*PARCEL:	
*OWNER/APPLICANT:	
PERMIT #:	
PROJECT:	HOME OF MY OWN - 3 BED RIGHT (2020 PLANS)

Single-Family Housing
THREE BEDROOM / TWO BATH - RIGHT PARKING
for

YAVAPAI COUNTY BUILDING DEPT.
() REVIEWED FOR CODE COMPLIANCE
() REVIEWED AS NOTED WITH CORRECTION
☒ ENGINEERING REVIEWED FOR DESIGN CRITERIA ONLY
THE ISSUANCE OF A PERMIT BASED ON PLANS, SPECIFICATIONS, AND OTHER DATA, SHALL NOT PREVENT THE BUILDING OFFICIAL FROM THEREAFTER REQUIRING THE CORRECTION OF ERRORS IN SAID PLANS, SPECIFICATIONS, AND OTHER DATA, OR FROM PREVENTING BUILDING OPERATIONS BEING CARRIED ON THEREAFTER, WHEN IN VIOLATION OF THIS CODE OR ANY OTHER ORDINANCES OF THIS JURISDICTION - SEC. 105.4
PLANS EXAMINER: [Signature] DATE

FLOOR PLAN (see sheet A-1.1 for Garage Alternate)

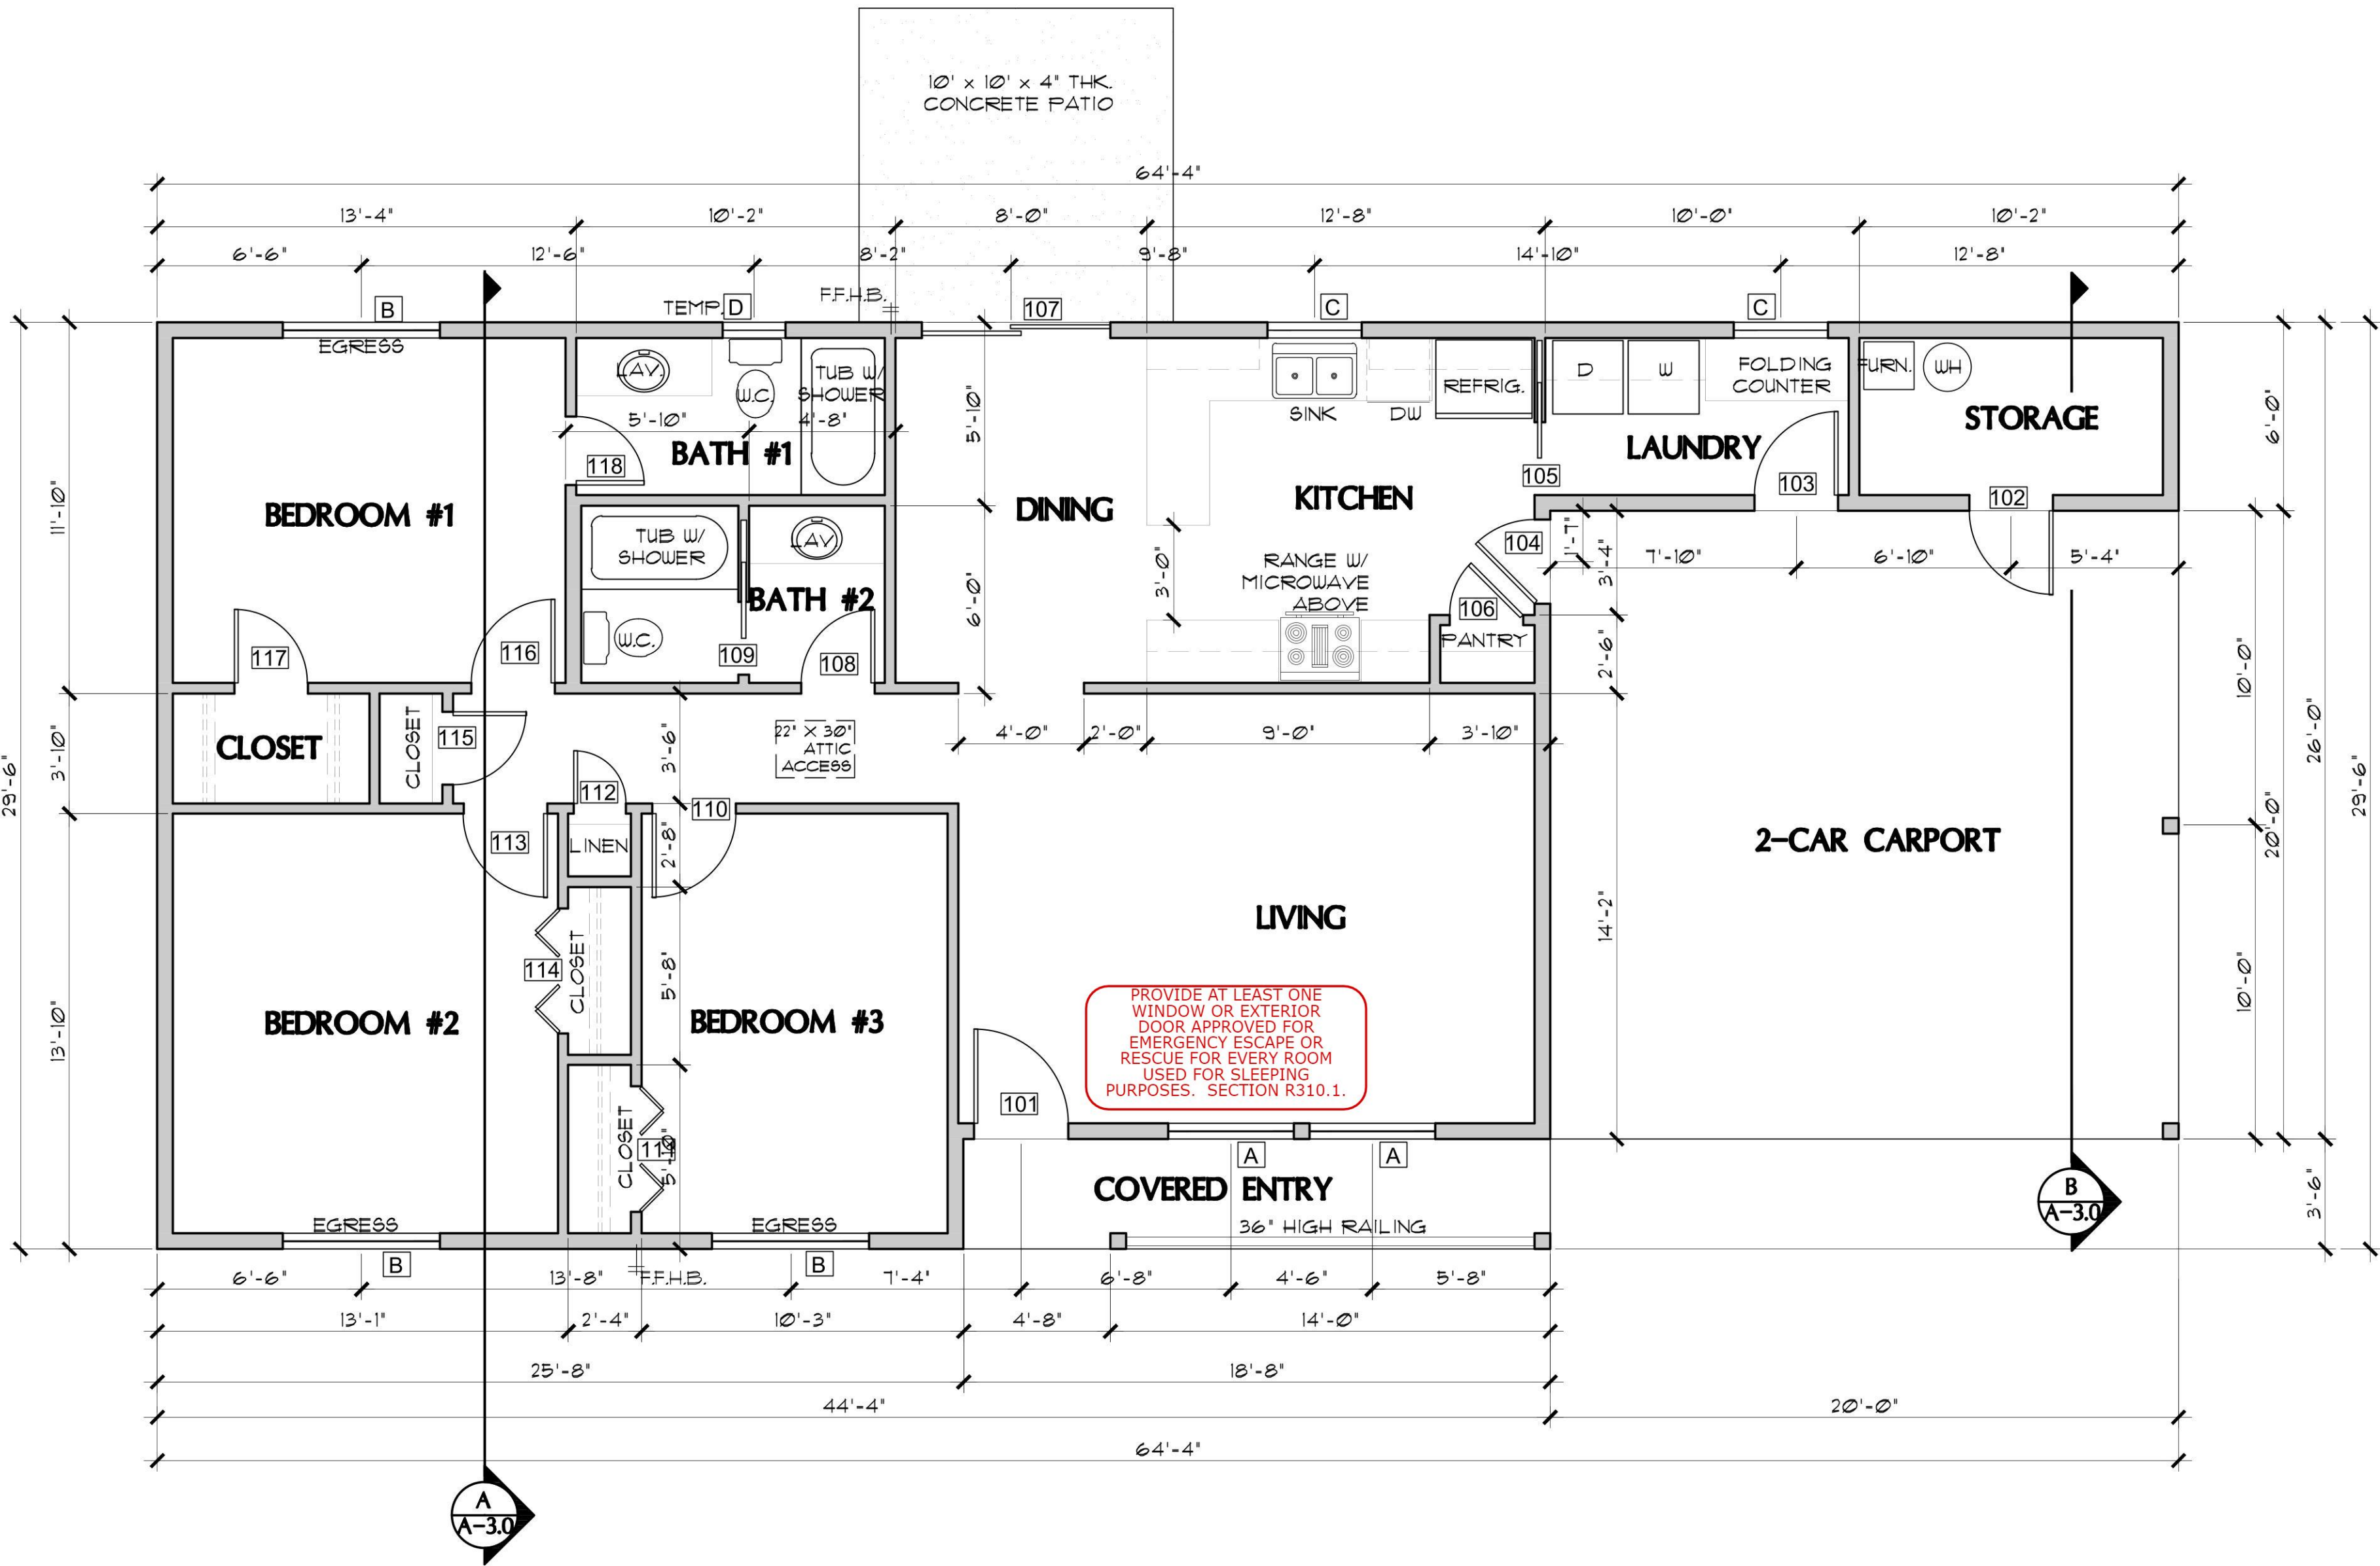
2018 IRC R311.3 There shall be a floor or landing on each side of the exterior door. The width of the landing shall not be less than the door served with a minimum distance of 36" measured in the direction traveled.

Provide at least one window or exterior door approved for emergency escape or rescue for every room used for sleeping purposes. 2018 IRC R310.1

Interconnected smoke detectors are required for this project per 2018 IRC R314.3.1. Each sleeping room, outside each sleeping room and on each floor level.

ALTERNATE GARAGE FLOOR PLAN

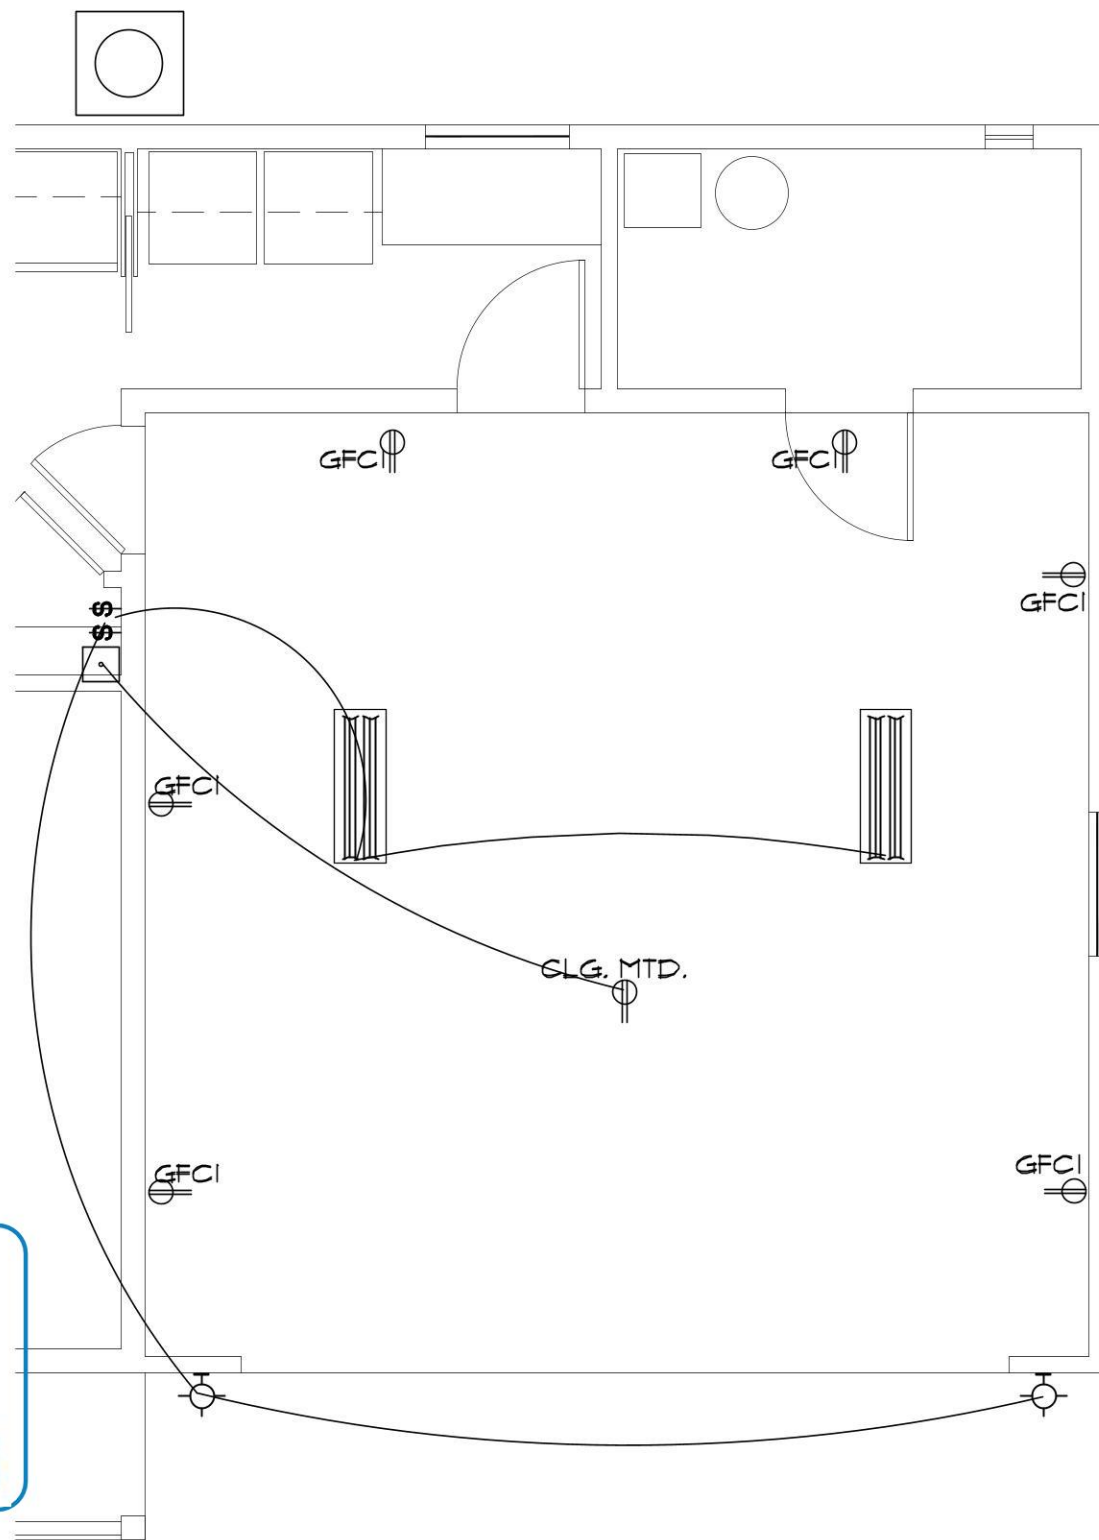
RAIN GUTTERS AND DOWNSPOUTS ARE REQUIRED

POSITIVE DRAINAGE AWAY FROM THE STRUCTURE IS REQUIRED

REFER TO THE GEOTECHNICAL REPORT FOR ANY

ADDITIONAL REQUIREMENTS

ALTERNATE GARAGE ELECTRICAL PLAN

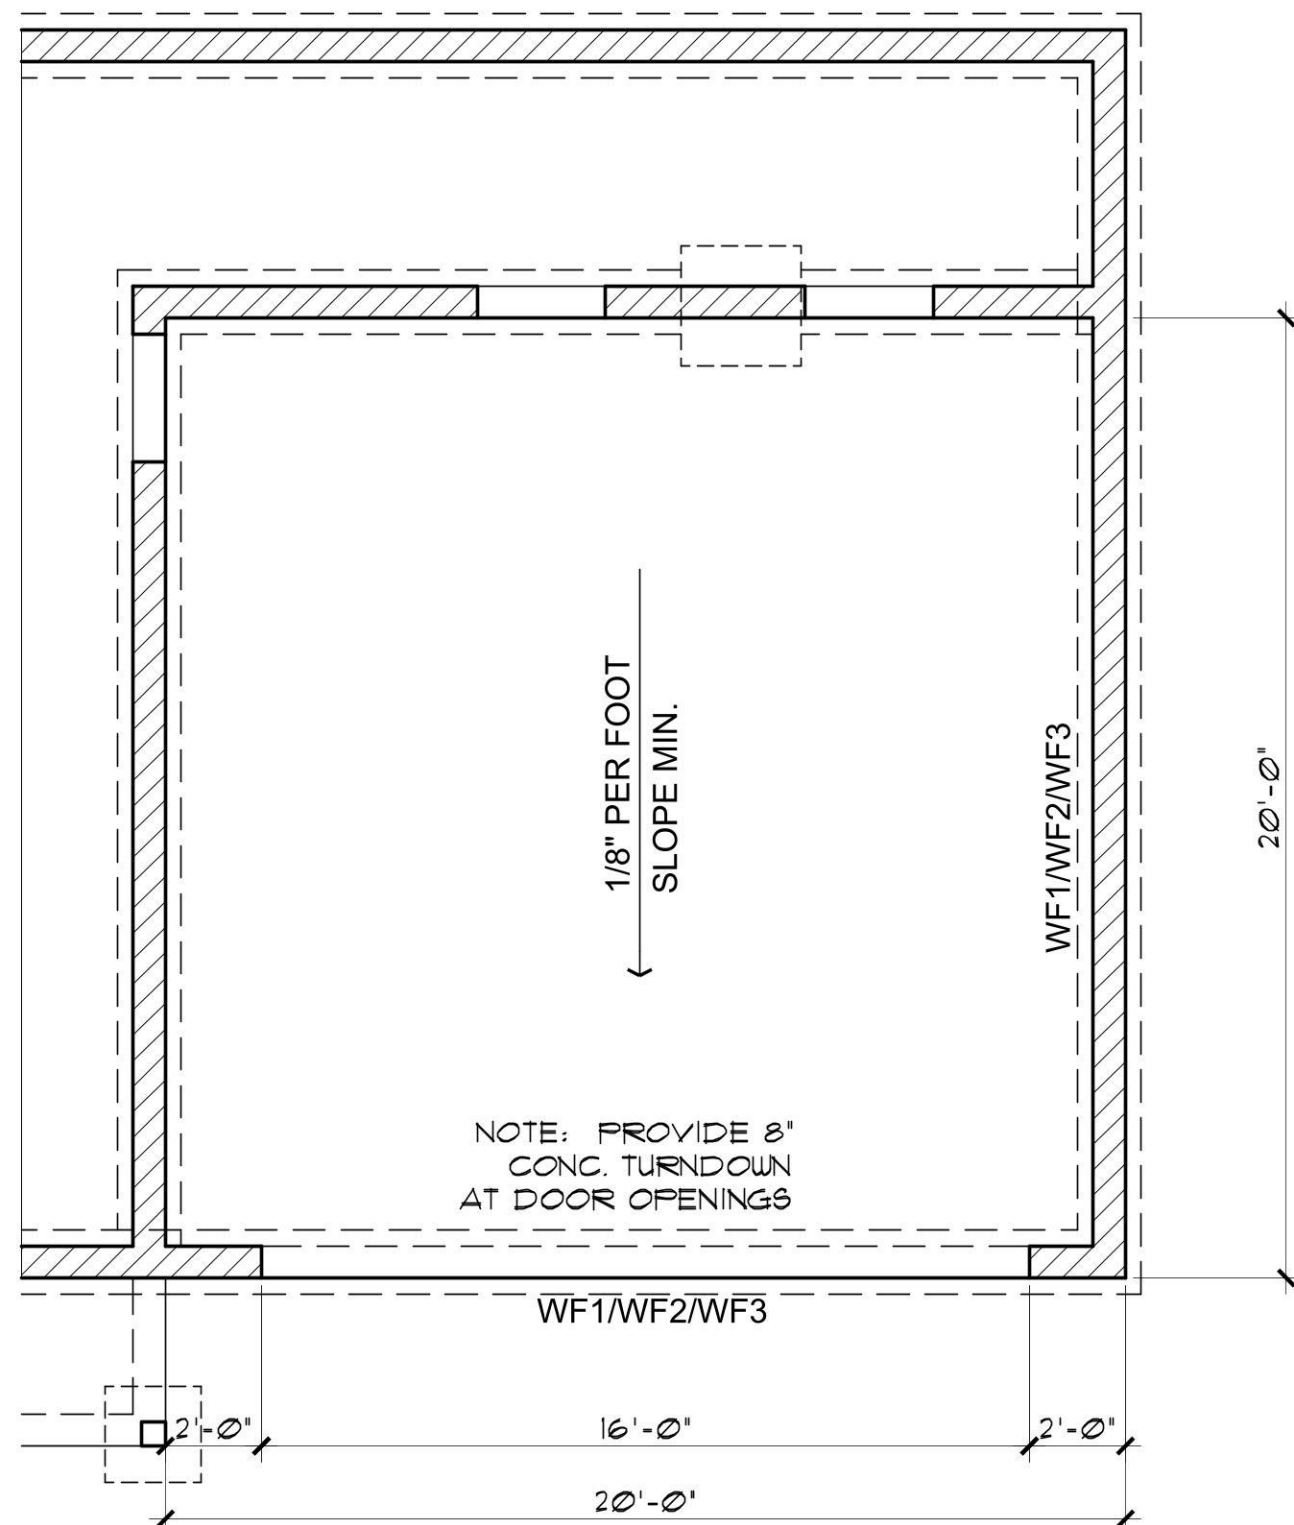
EFFECTIVE APRIL 20, 2006
FULLY SHIELDED FIXTURES ARE
REQUIRED FOR ALL EXTERIOR LAMPS

ALTERNATE GARAGE FOUNDATION PLAN

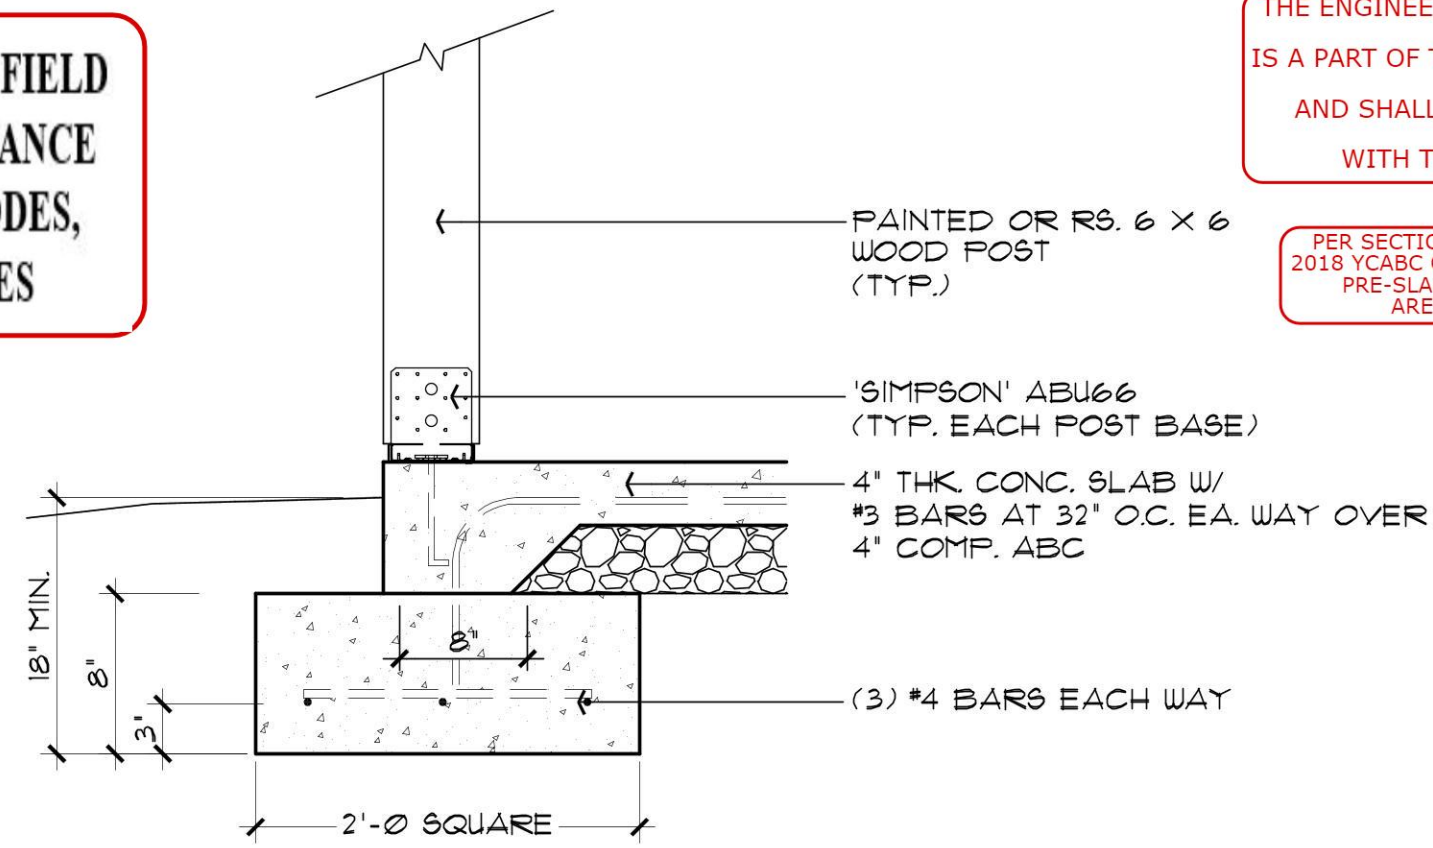
PER SECTION 110.3.4 OF THE
2018 YCABC ORDINANCE 2014-1:
PRE-SLAB INSPECTIONS
ARE REQUIRED
